August 6, 2018

Re: Review of Water Pack and Keller-Bliesner Engineering R9 Ranch Reports

Figure 1 – Groundwater Level Measurement Sites

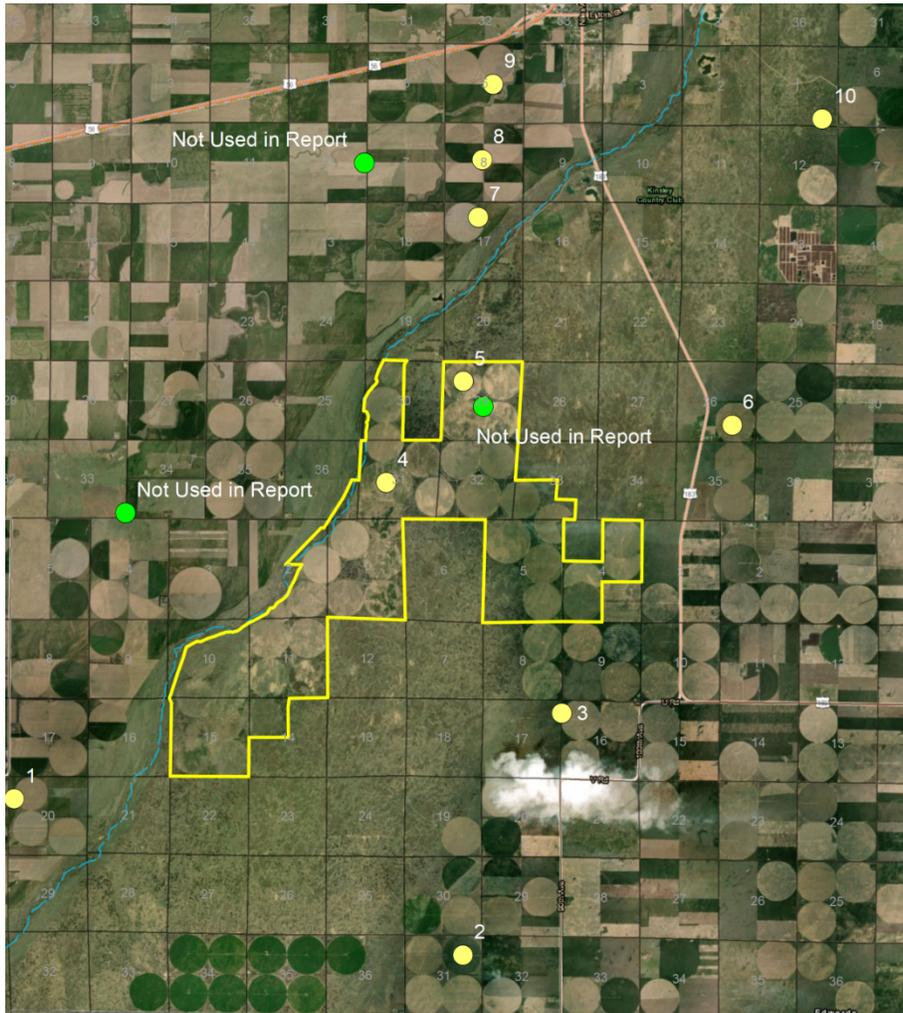
- For the water-level analysis, KBE selected the ten wells shown in yellow on slide five from his PowerPoint and in Figure 1 below.
 - a. Only two of the ten wells KBE selected (#4 and #5) are actually on the R9 Ranch.
 - b. The remaining wells range from 1.25 miles to more than 4.5 miles from the nearest R9 Ranch boundary.
 - i. Three wells are 1.25–2.5 miles away,
 - ii. Two wells are 2.5–3.5 miles away,
 - iii. Three wells are 3.5–4.5 miles away, and
 - iv. One well is over 4.5 miles away from the R9 Ranch.

- There was additional publicly available water-level data that KBE could have used but did not. Those sites are shown in green on Figure 1.
 - a. It is unclear why KBE declined to use water levels from the additional data point available within the boundaries of the R9 Ranch.
 - b. It is unclear why KBE selected the specific wells plotted in yellow within Figure 1, as many are too far from the R9 Ranch, with too many changes in pumping density, to reasonably correlate to water level trends on the R9 Ranch itself, and too far to have any bearing on the water rights change applications.

- c. It is unclear why KBE excluded a number of publicly available water level monitoring sites in the vicinity of the R9 Ranch (as plotted in green in Figure 1) that are as close or closer to the R9 Ranch than those that KBE selected.

The omission of data from other wells on the R9 Ranch, and the inclusion of data from wells too far away from the R9 Ranch to be material, raises significant questions about KBE’s interpretation of the local hydrogeology and the validity of their conclusions.

Figure 2 – Water level plots and trends from KBE’s public presentation June 21, 2018

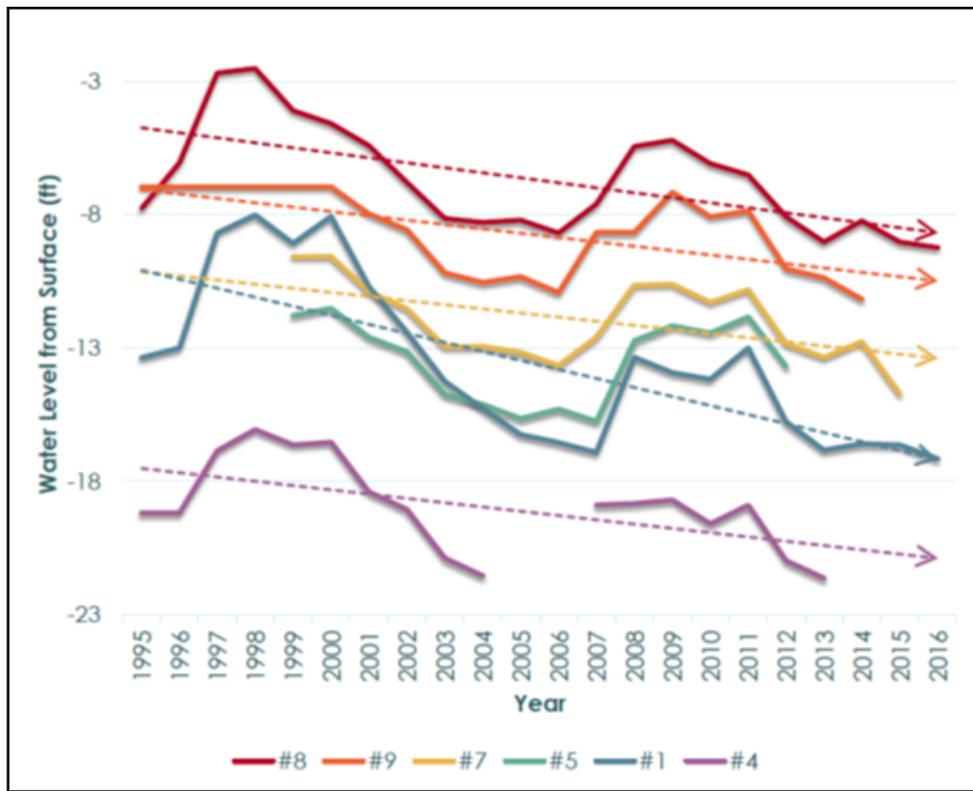
KBE graphs water levels and trend lines for the ten wells selected as a representation of water levels on the R9 Ranch, (see Figures 2 and 3 sourced from the KBE presentation). KBE concludes from these graphs that water levels on and near the R9 Ranch are in a state of decline.

The water-level graphs KBE presented illustrate a skewed and unrealistically negative picture of water levels by selecting the period of 1995 through 2016. This period begins with several very wet years (1995-1997). Shallow groundwater systems such as that of the R9 Ranch are very responsive to recharge from annual precipitation, and this is reflected by water level rises in each of the hydrographs. The period of record ends in 2016 at the tail end of a historic drought period that began during the fall of 2010. This drought resulted in water level declines in each of the hydrographs. No justification was provided for utilizing the period from 1995-2016 nor for the exclusion of the additional water level data available for multiple sites both prior to 1995 and after 2016.

Figure 4 - KBE Well #4 (located on the R9 Ranch)

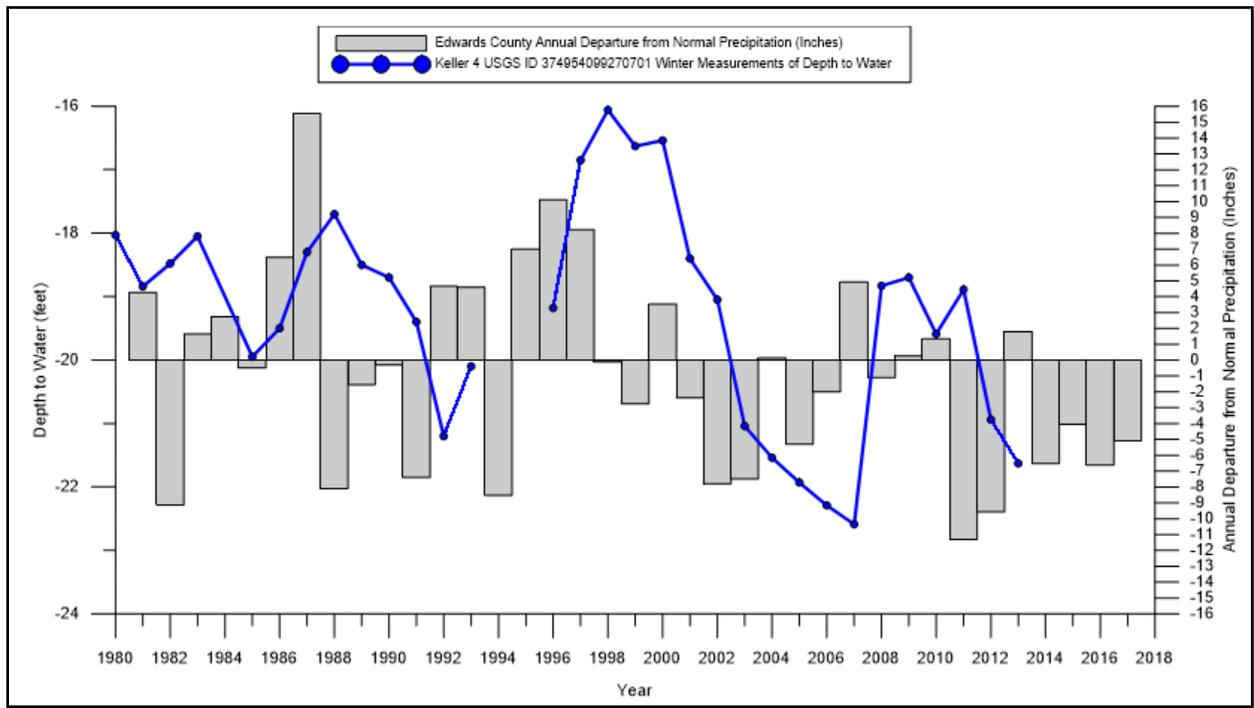
As shown in Figure 4, Edwards County received much greater than average precipitation in 1995, 1996, and 1997. This is the same time frame for which Keller begins graphing water levels. According to the U.S. Drought Monitor, Edwards County was in an “extreme” to “exceptional” drought for much of 2011–2013. Naturally, the water level for KBE Well #4 was on a downward cycle at the last available data point for depth to water in 2013. Note that examination of the full available period of record shows clear historic cycles of declines and rises in water-level changes proportional to annual precipitation.

Figure 5 - KBE Well #5 (located on the R9 Ranch)

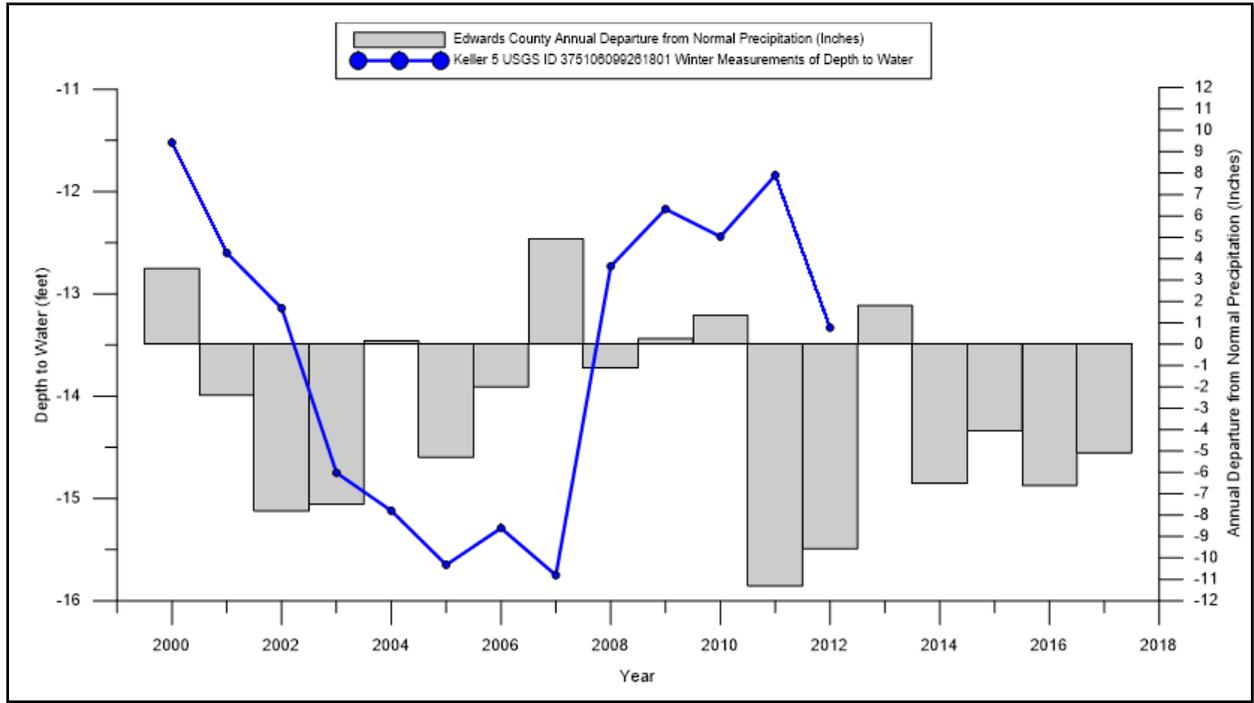
A similar pattern of sustainable water-level fluctuation applies to KBE Well #5, the only other well located on the Ranch that was included in KBE’s study.

Figure 6 - Water Level Monitoring Point 375055099255301 (located on the R9 Ranch)

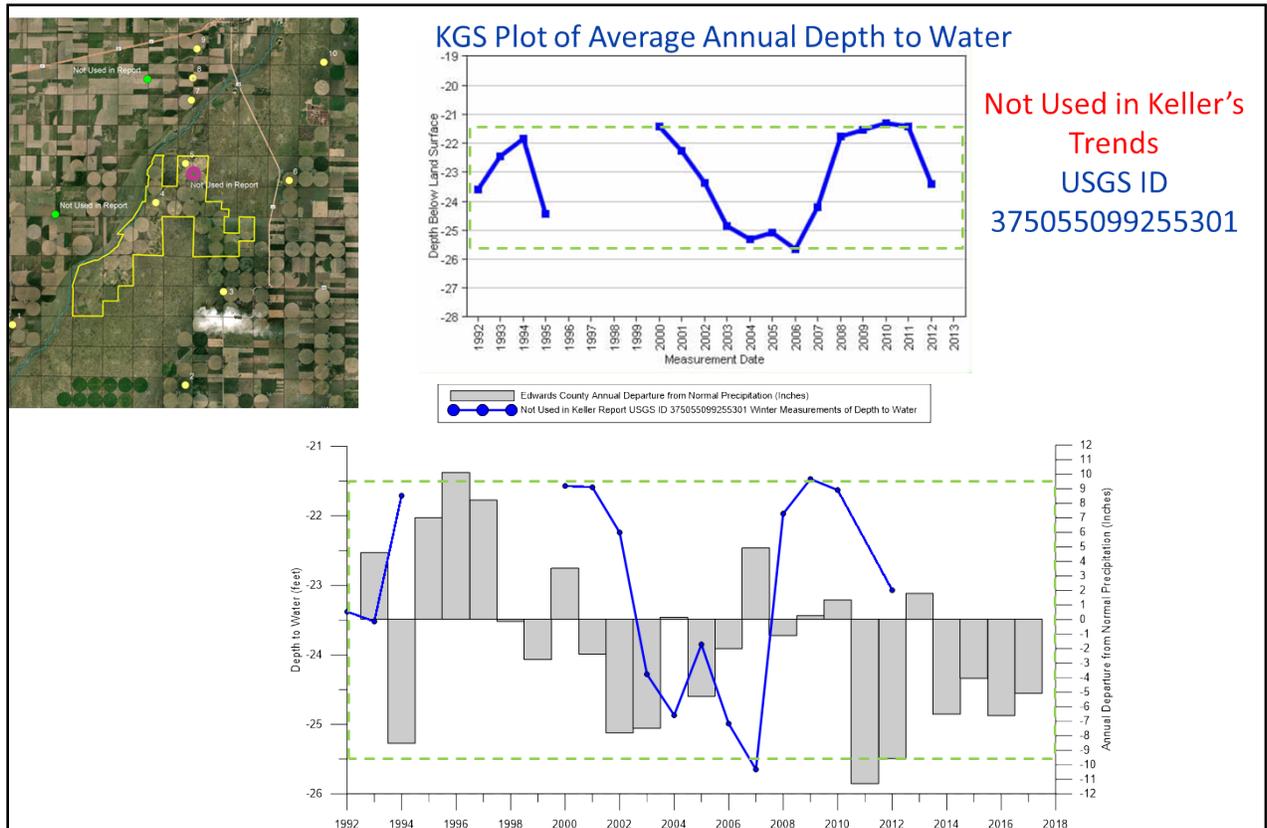
Another well (USGS ID 375055099255301) located immediately to the southeast of KBE Well #5, had data available but KBE declined to include in their study, confirms a similar water-level fluctuation of approximately four feet that cycles with precipitation, but does not indicate any long-term downward trend (Figure 6).

Figure 10 - KBE Well #7 located 1.8 miles north of the R9 Ranch

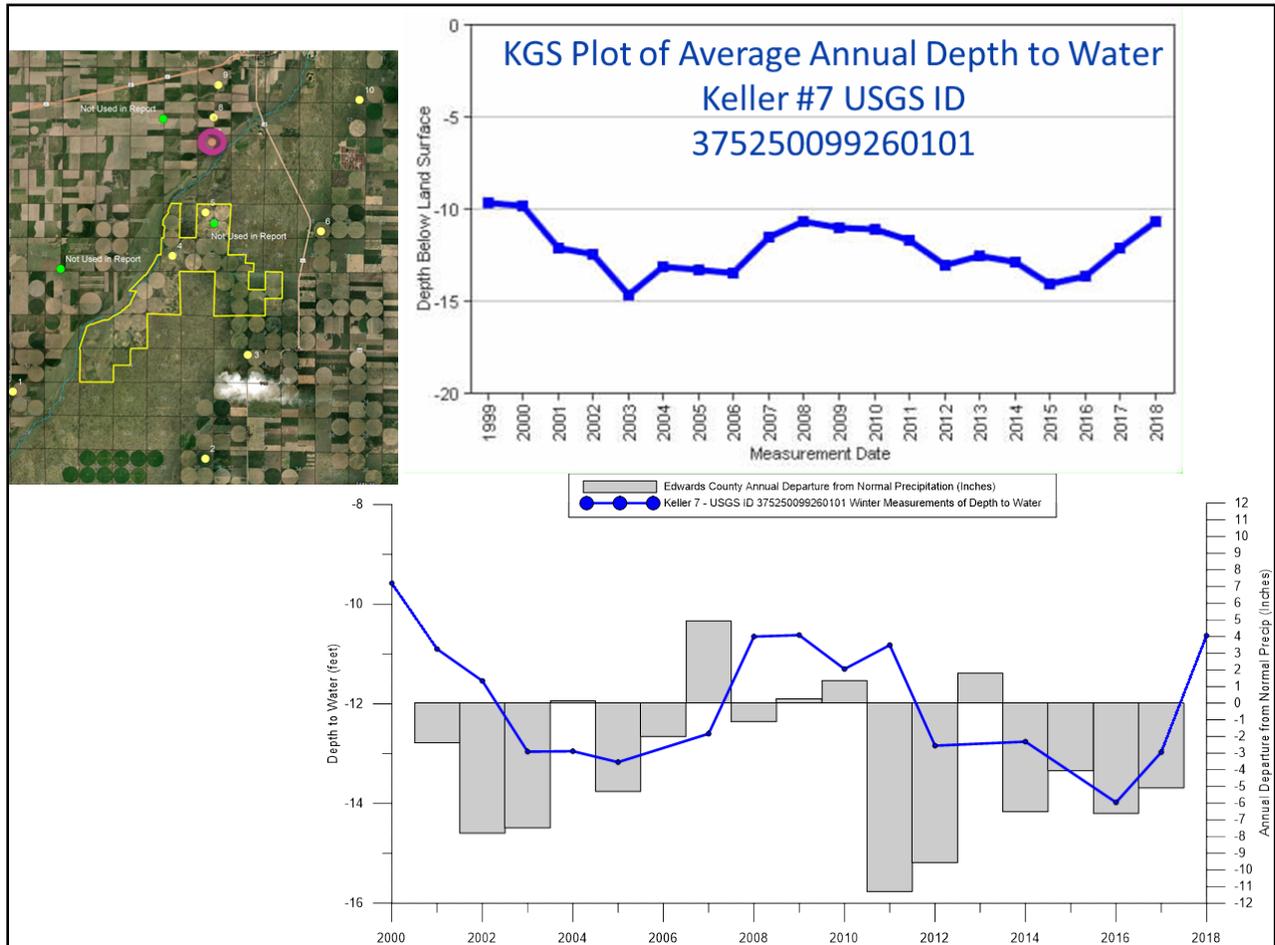
As shown in Figures 10 and 11, other wells included in KBE’s study follow a similar sustainable water level pattern when the full period of record and all of the available data is included.

Figure 11 - Keller Well #8 located 2.5 miles north of the R9 Ranch

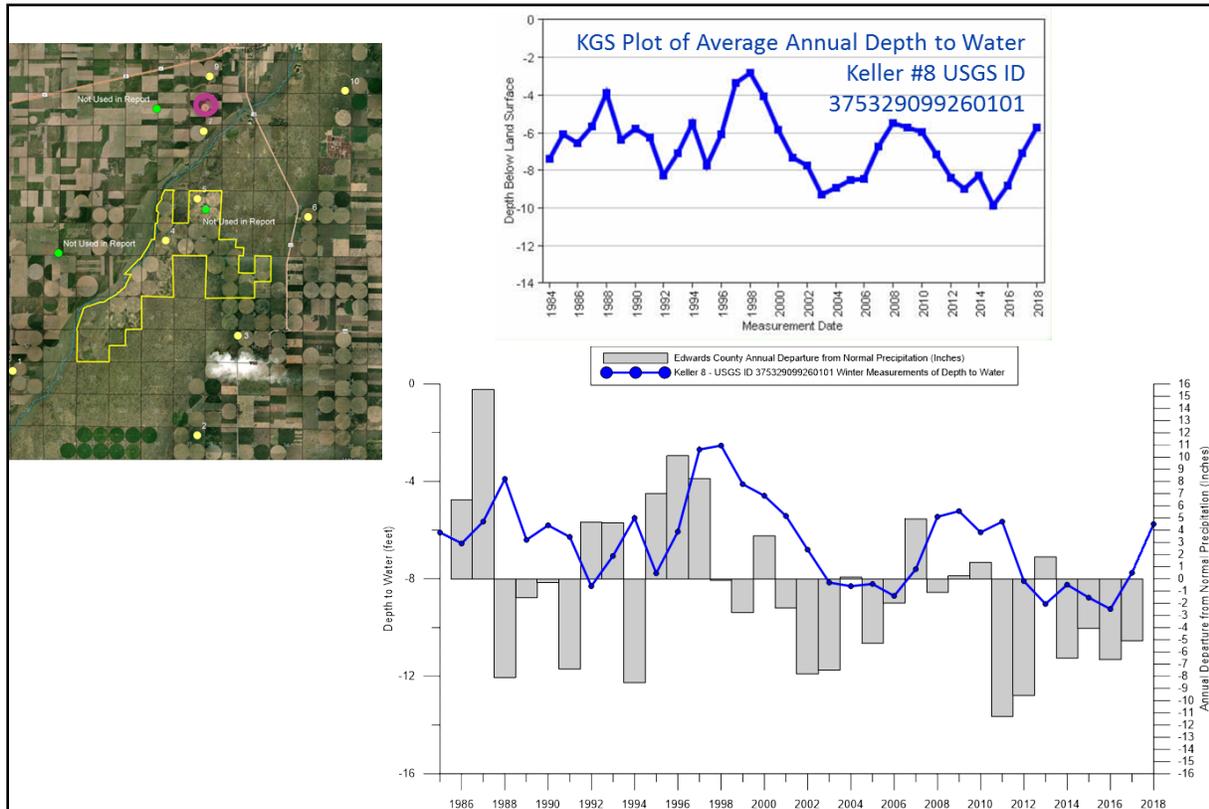
Nearly all of the wells near the R9 Ranch (and all of them on the R9 Ranch), reflect stable water levels when looking at the full period of record.
